RE: 3821 12th Street NW
Grading and Drainage Plan
Engineer's Stamp Date: 11/24/20
Hydrology File: G14D096

Based upon the information provided in your submittal received 04/06/2021, the Grading & Drainage Plan **is not** approved for Building Permit. The following comments need to be addressed for approval of the above referenced project:

GRADING &
DRAINAGE
PLAN

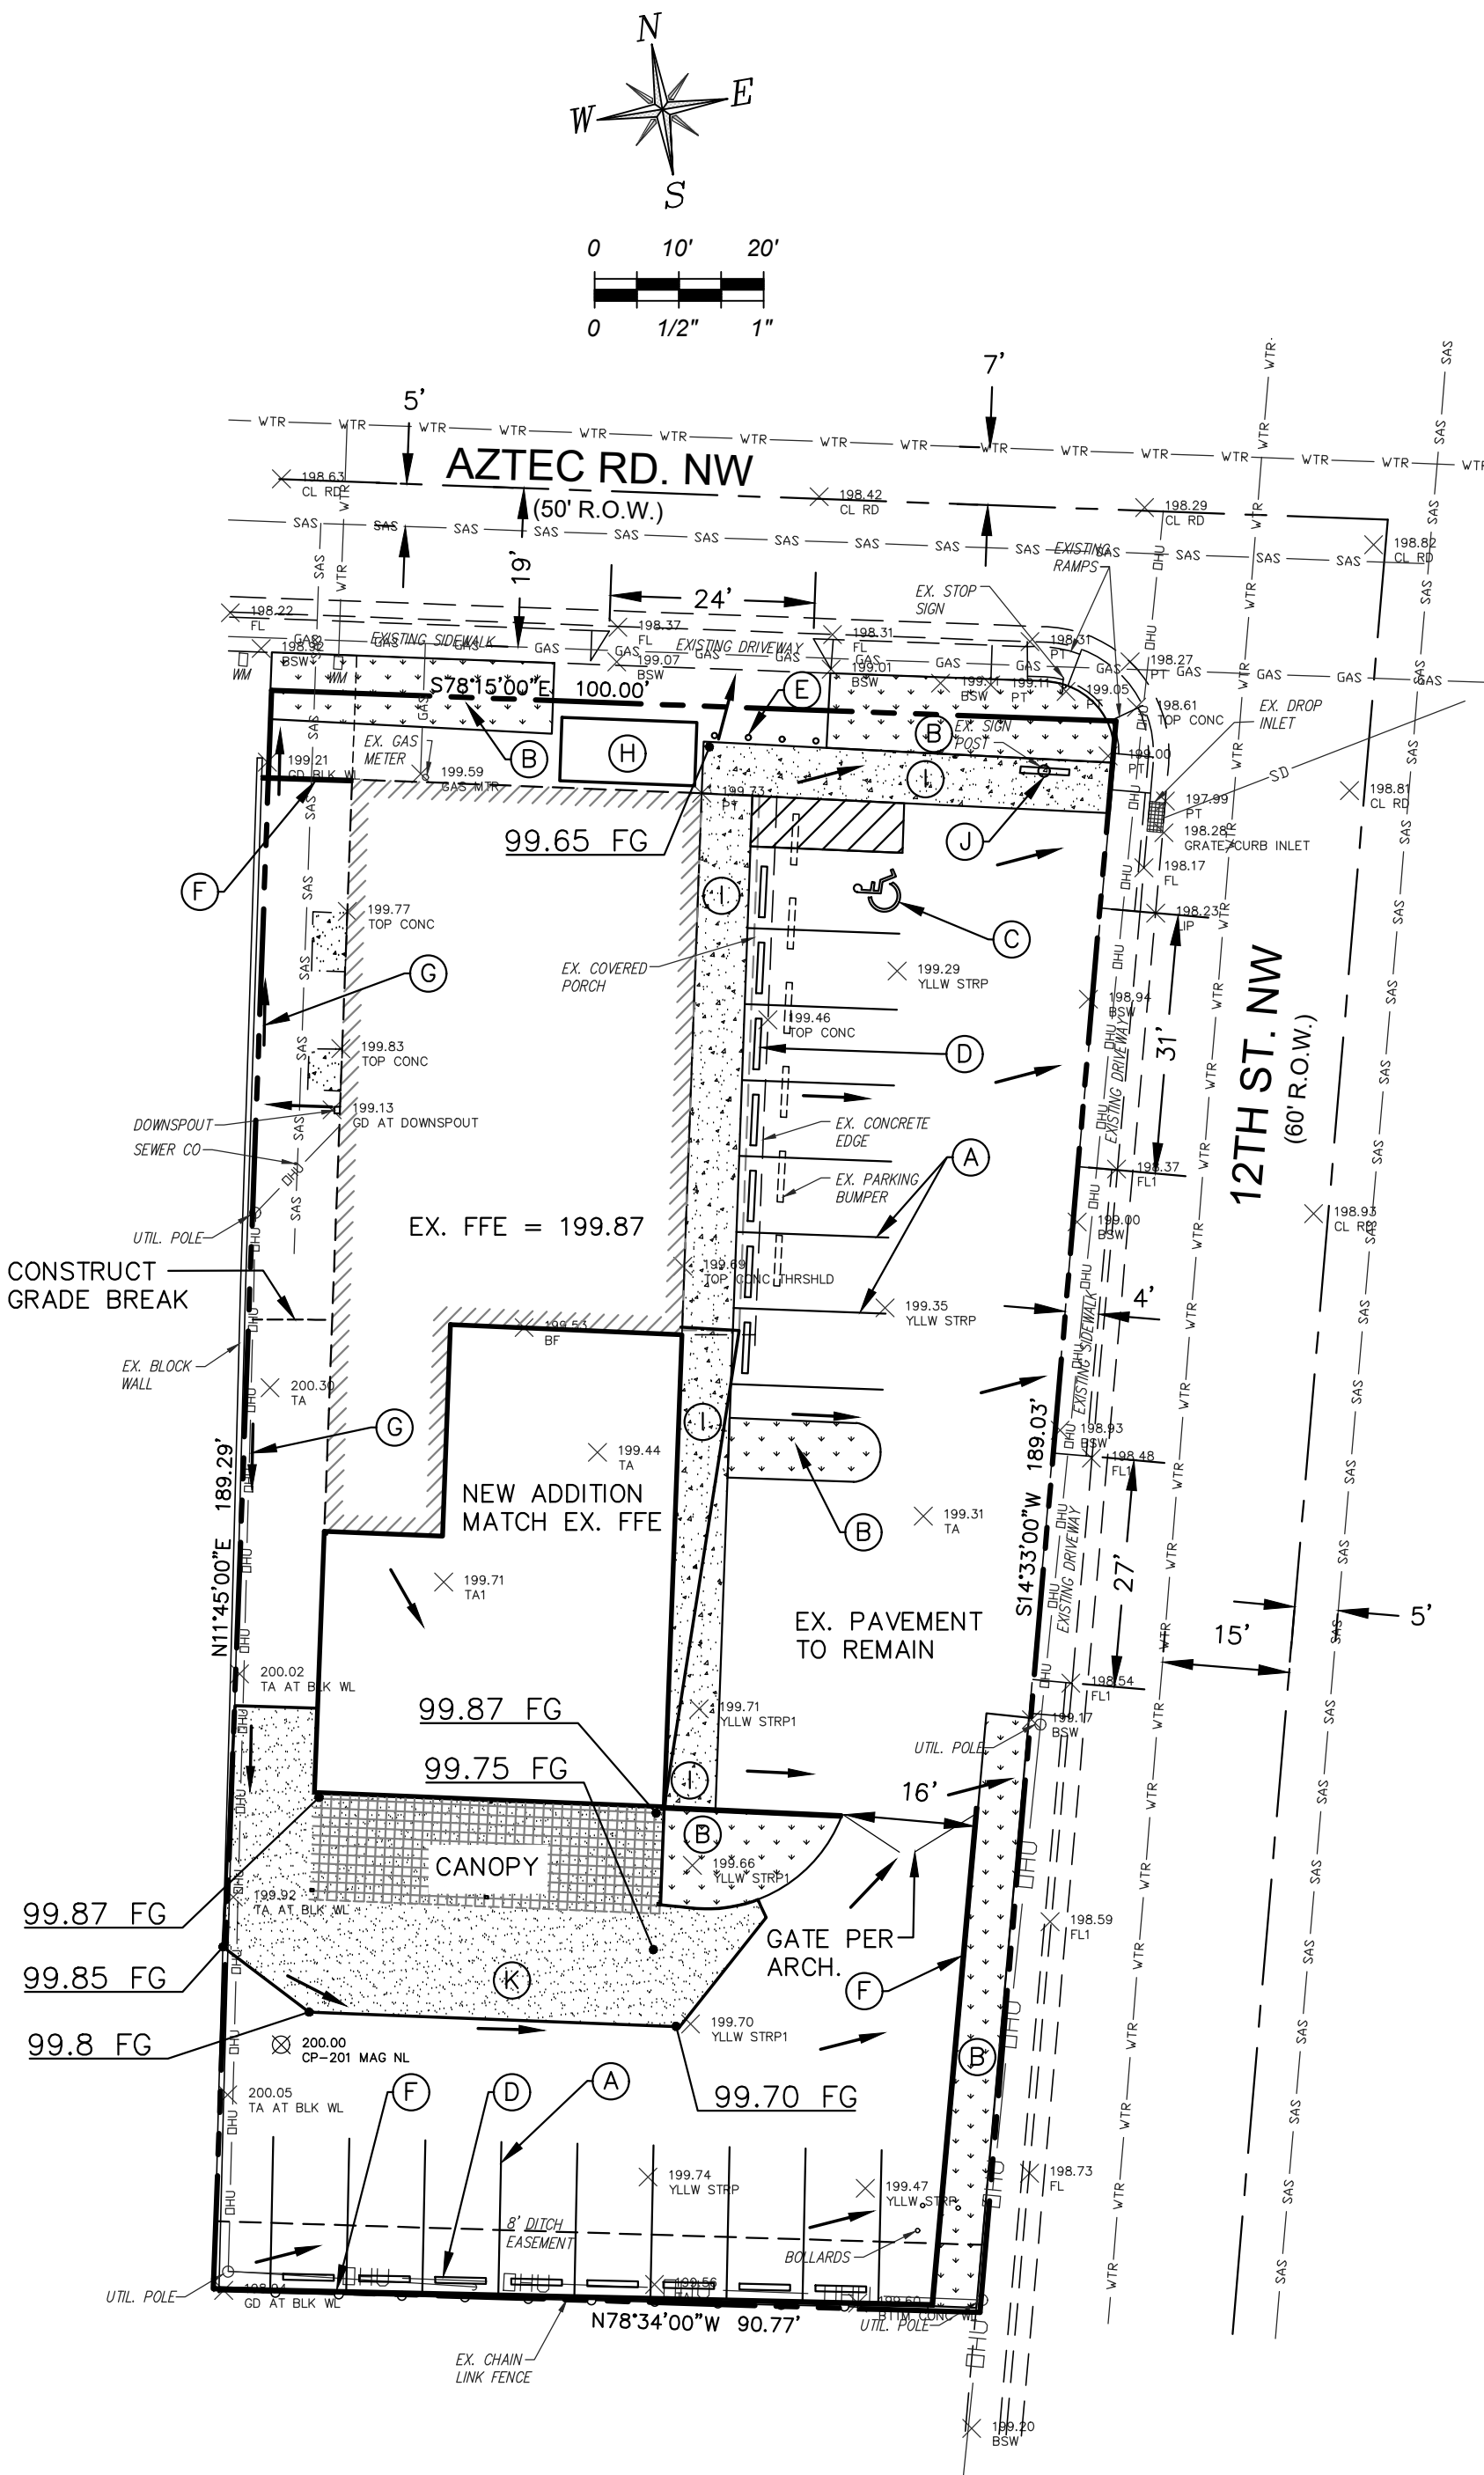
1. Please use the procedure for 40 acre and smaller basins as outlined in Development Process Manual (DPM) (signed 06/08/20) Article 6-2(a). Please provide both the existing conditions and proposed conditions for the 100-year 6-hour storm event.

2. Provide management onsite for the Stormwater Quality Volume (SWQV) in accordance with the new drainage ordinance, § 14-5-2-6 (H) enacted 10/2/18 (Council Bill C/S O-18-2) and as outlined in DPM (signed 06/08/20) Article 6-12 Stormwater Quality and Low-Impact Development for the sizing calculations. Since this site is a redevelopment the SWQ pond volume will be $0.26 * \text{new impervious area (new paving, sidewalks, and building) (sf)} * 1/12$. If you are planning to provide for the SWQ volume, please show the top and bottom of the ponds along with the volume for each pond within the landscape areas. The onsite drainage should be directed to these ponds via curb cuts prior to either being collected in the existing inlet or leaving the site for the public drainage system. If you are going to not provide for the SWQ volume within the landscape areas, then you will need to add a statement, "The Owner has elected to pay for the Stormwater Quality Volume. The Payment-in-lieu will be $\$8 / \text{CF} * \text{SWQ volume (CF)} = \$ \text{XX}$."
